September 30, 2013

Second Modification to EPA's Final Determination for the South Terminal Project – Additional Dredging and Blasting for Rock Removal

SECOND MODIFICATION SUMMARY: After completing consultation with other federal and state agencies, as required by federal and state law, and after reviewing additional submissions by the Commonwealth, EPA has determined that the Commonwealth's request for a Second Modification to EPA's Final Determination for the South Terminal Project, issued on November 19, 2012 ("the Final Determination" or "FD"), is both protective of human health and the environment, meets the substantive requirements of applicable or relevant and appropriate federal environmental standards and, through the Commonwealth's determination, meets applicable or relevant and appropriate state environmental standards, as long as the conditions set forth in this Second Modification are met. Through this Second Modification to the Final Determination, EPA is modifying the South Terminal Project portion of the State Enhanced Remedy ("State Enhanced Remedy" or "SER"), which is incorporated into the 1998 Record of Decision for the Upper and Lower Harbor at the New Bedford

**Figure 1
Map of 200' Northern Dredging Expansion of Deep Draft
Area**

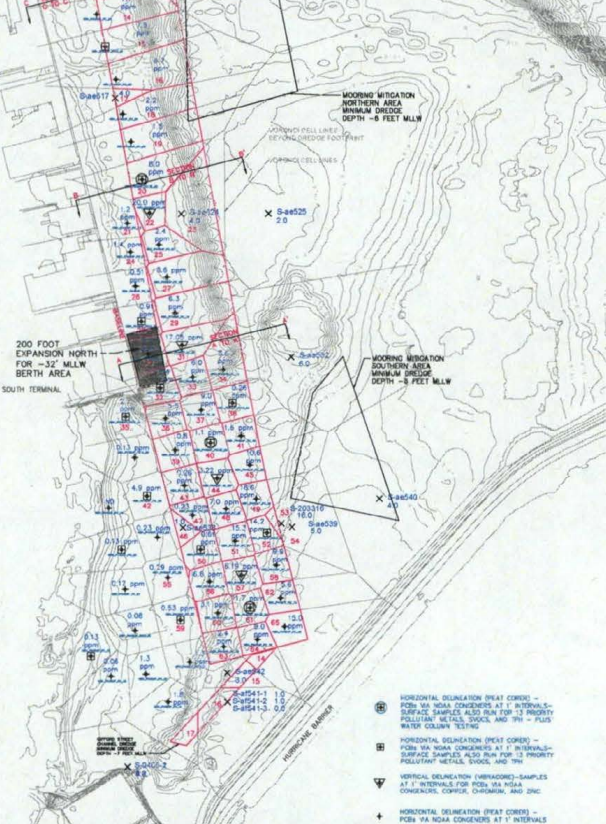
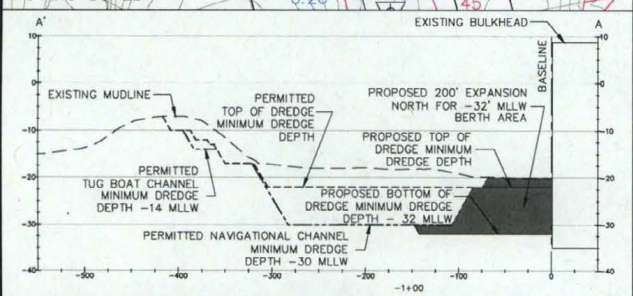
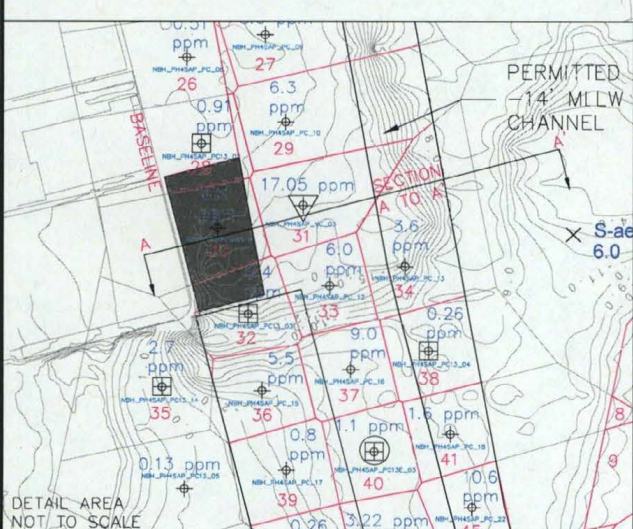
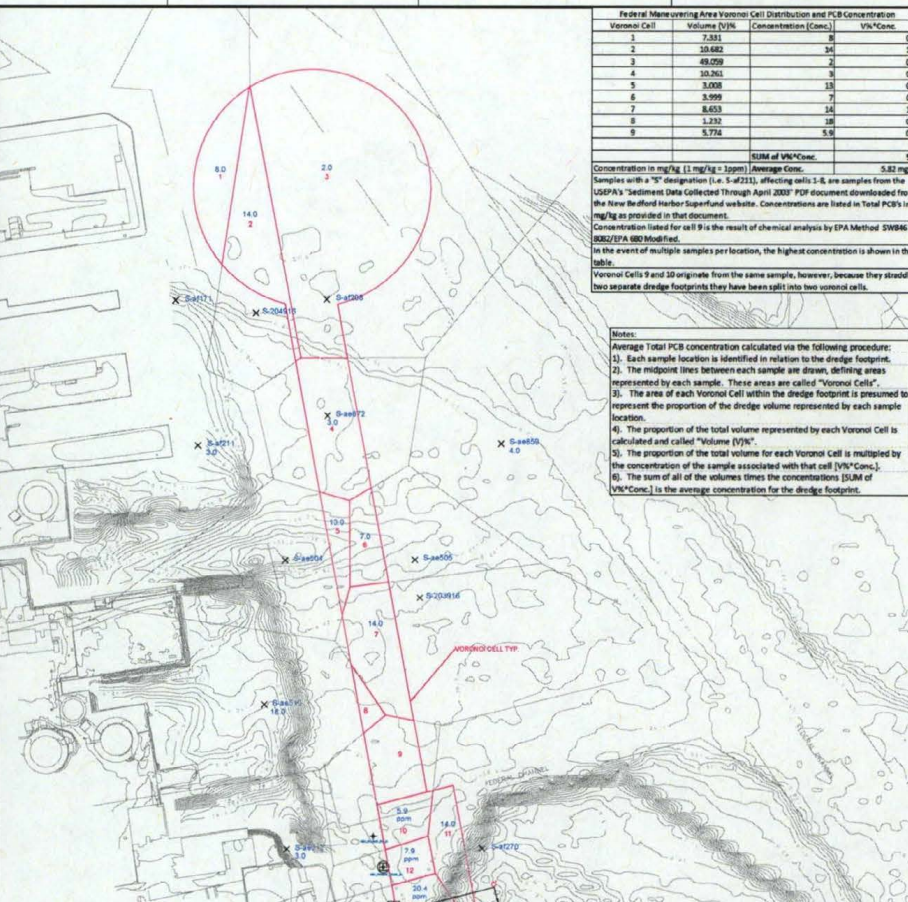
The additional dredging at the deep draft berthing area would extend north by 200 feet the area authorized in the Final Determination, beginning at the southeastern edge of the existing Shuster bulkhead and ending at the northeast corner of the Shuster bulkhead, resulting in a total of 800 feet of deep draft area along the South Terminal facility. Depths will change from the existing -20 MLLW to a depth of -32 MLLW. Approximately 2,500 cubic yards of contaminated sediment and 8,000 cubic yards of clean sediment will be generated by this expansion. Contaminated sediment will be disposed in CAD cell 3; clean dredged material will be used as fill during construction of the terminal. See map at Figure 1.

Figure 2
Map of 50' Widening of Channel

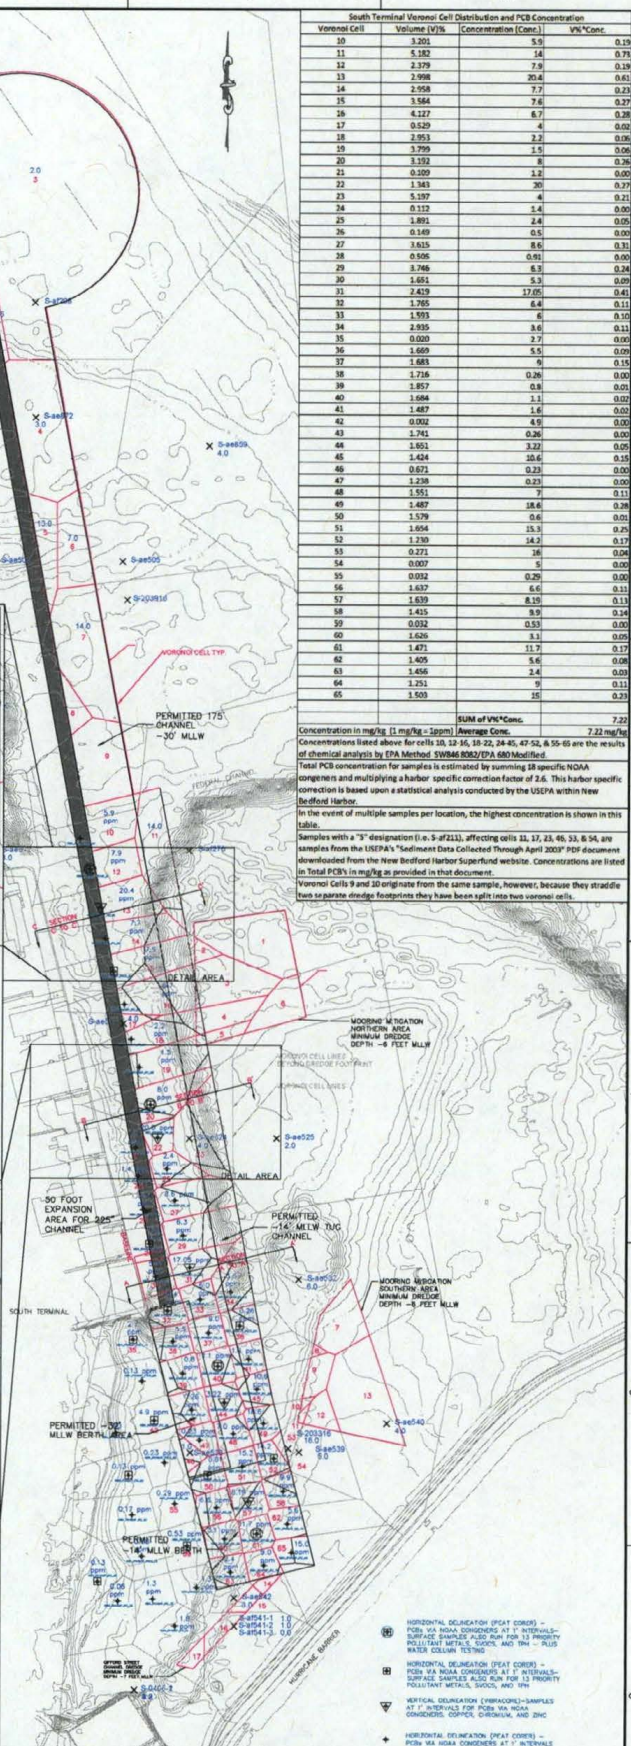
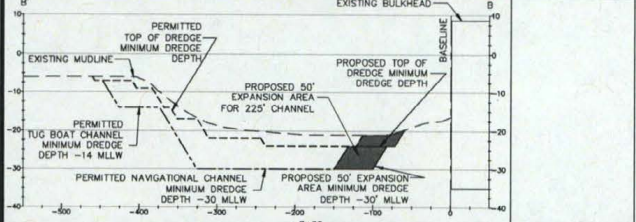
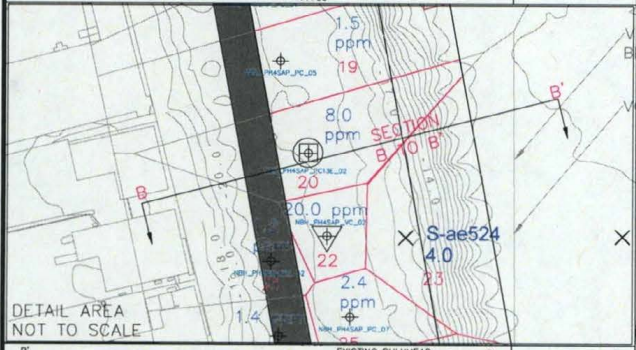
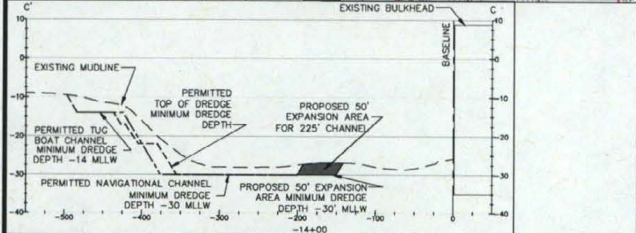
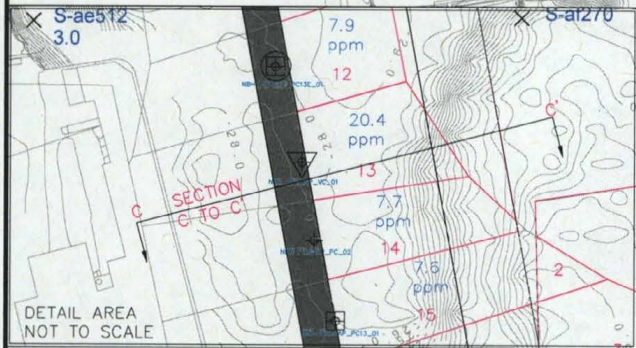
The additional 50 foot width channel expansion will occur on the western, or landward, side of the 175 foot channel authorized in the Final Determination. This area west of the channel is already at a depth of -20 to -30 MLLW and will only need slightly more dredging to bring it to -32 MLLW, generating approximately 8,500 cubic yards of contaminated material and 7,000 cubic yards of clean material. Disposal of the contaminated and clean dredged material will be the same as disposal of the deep draft dredged material. See map at Figure 2.

**Figure 3
Map of Three Blast Areas**

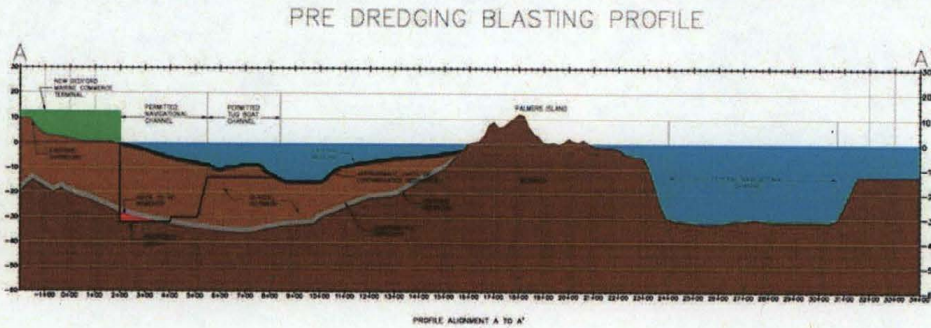
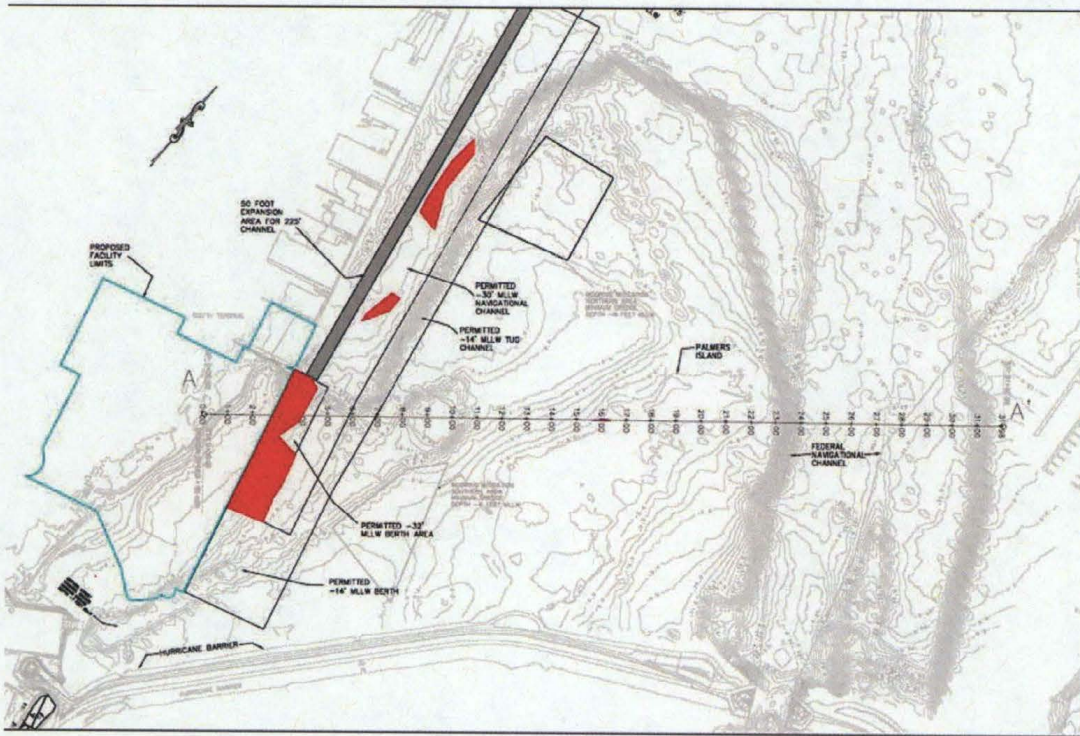
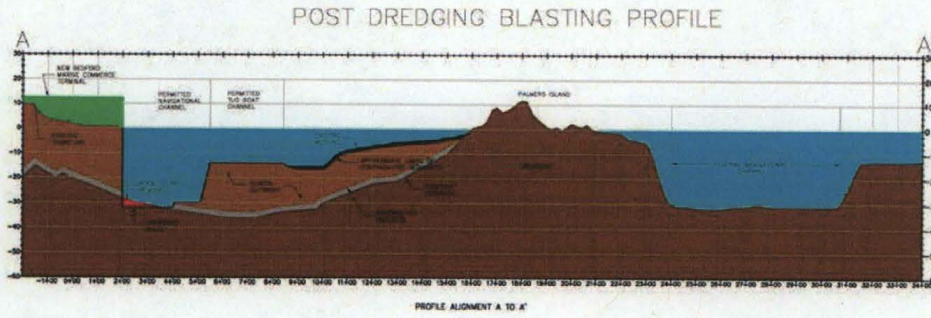
The intersection of shallow rock and the overburden is located very close to the bottom of the dredge footprint primarily along the immediate eastern face of the bulkhead in the deep draft dredge area. Three areas may require blasting, one in the vicinity of the berthing area and the other two in the approach channel (See Figure 3). Before blasting occurs, all contaminated sediment will be removed, leaving a clean overburden layer above the bedrock. This overburden layer will remain in place during blasting to provide a positive dampening effect on the acoustical impacts of blasting. A drill rig will then drill through the rock to an appropriate depth and blast charges of varying amounts up to 150 pounds per delay, depending on the thickness of the rock, will be placed into the holes. A technique called "stemming" will be used which consists of placing crushed rock into the top of the hole to further dampen the shock wave reaching the water column that will assist in reducing fish mortality. A two hour Notice to Blast will be given at the

2. Blasting shall only be conducted in the three locations depicted on page 4 of the Commonwealth's May 20, 2013 letter to EPA (See Figure 3 of this document). Blasting at the site closest to the bulkhead construction area may occur between September 15 and January 15. Blasting at the other two locations may occur between November 15 and January 15, and might also be able to occur earlier than November 15 if EPA specifically approves in writing an earlier start date for one or both sites following completion of the blasting at the bulkhead site and EPA's evaluation of the monitoring results (discussed further below).

**Figure 5
Map of 1500 foot zone for potential vibrations from
blasting**

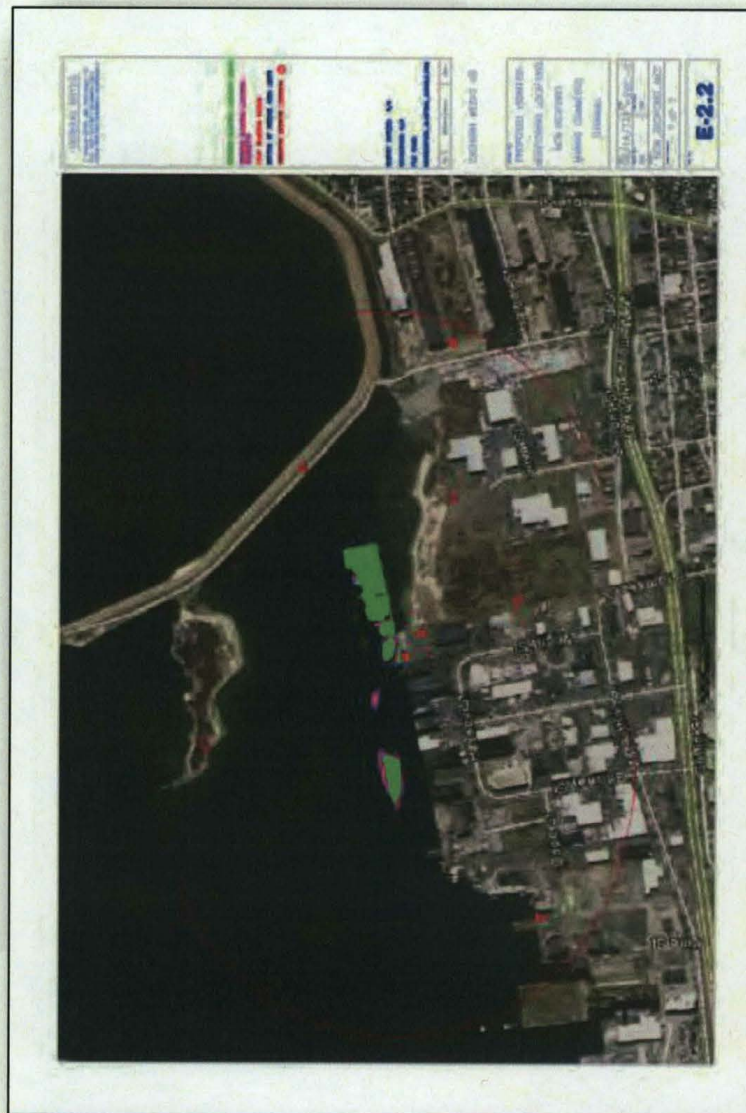
An additional historic property, the Palmer Island Light Station (the Light Station), has recently been identified within the Project area that was not included within the scope of the original assessment. More specifically, the Light Station is located within the 1500 foot zone where potential vibrations may occur from blasting. See Figure 5.
